SUBJECT: Forwards addl info re relief request for core flood nozzle weld insps & fracture mechanics analyses.

OG-1365  
April 13, 1994  
JHT/94-58

Subject: Relief from Code Request Using B&WOG Demonstration  
of Ultrasonics Techniques

**FRACTURE MECHANICS EVALUATION  
for  
B&W DESIGNED PLANT OCONEE-3**

**Summary of Fracture Mechanics Analysis  
of  
Postulated Flaws in a  
Core Flood Nozzle**

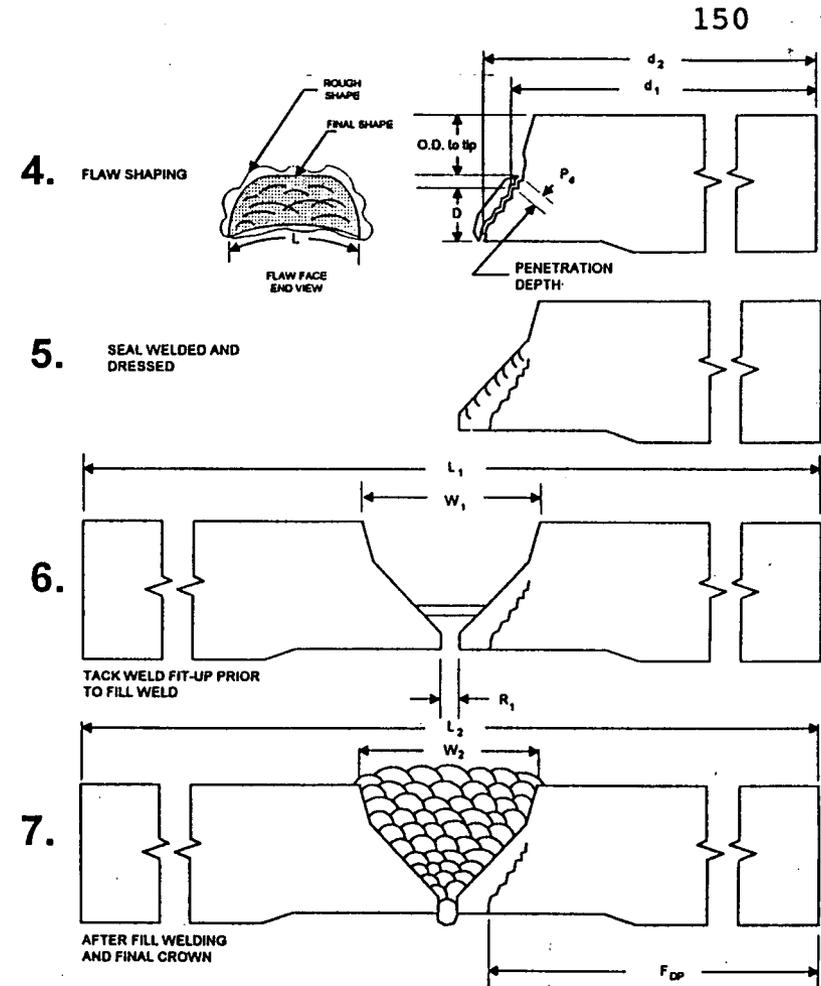
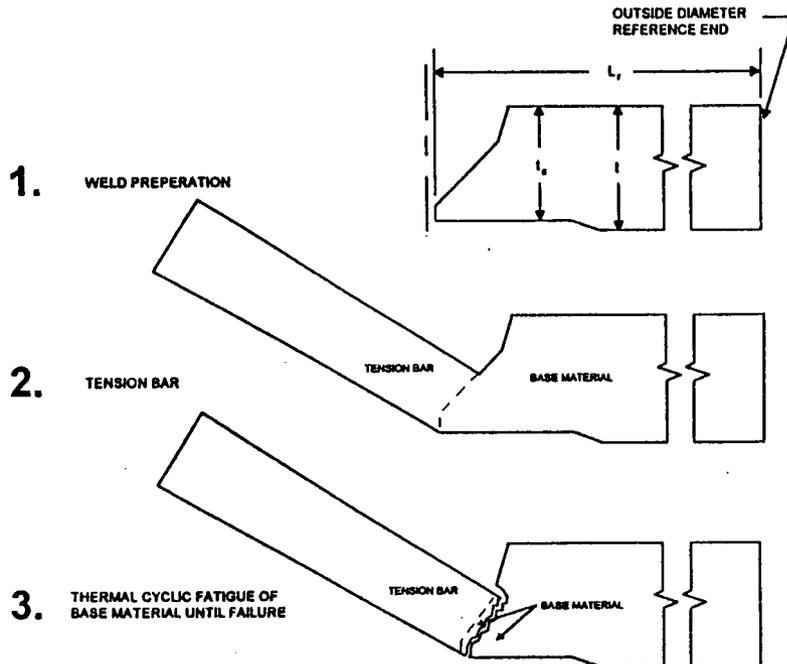
The maximum expected allowable flaw sizes ( flaws considered acceptable during the current ISI period) assuming the conservative flaw geometry of a 360 degree external circumferential flaw and that meets ASME Section XI, IWB-3612 for the next 10 year interval is in the range of 45% to 55% of the wall thickness at the locations of the nozzle to safe-end weld and safe-end to pipe weld.

These maximum allowable sizes are well above the minimum demonstrated detectable flaws (7-15%) demonstrated in the 1993 B&WOG UT Demonstration.

It should be noted that while there are uncertainties in all results, the conservative use of a 360 degree external flaw in this comparison could be replaced with more realistic semi-elliptical flaws, if added safety margin was thought to be needed, we believe the point is made without additional considerations.
